C30665

IGHQEX3000

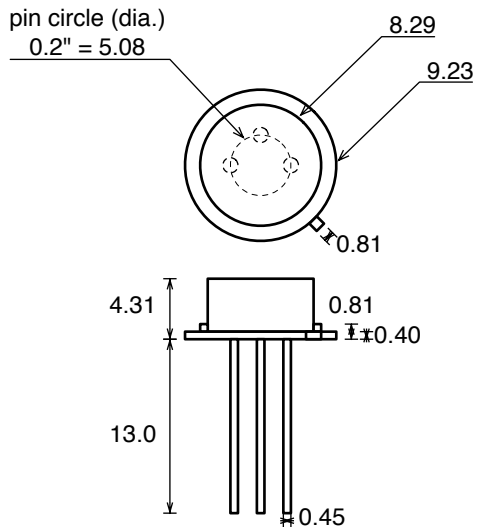
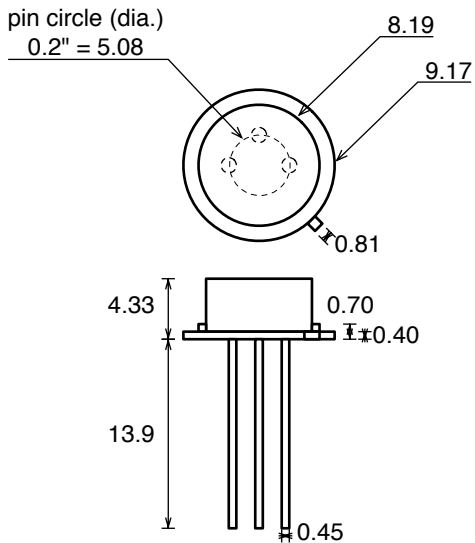
Leg length
to be cut at ~11mm
from the cap
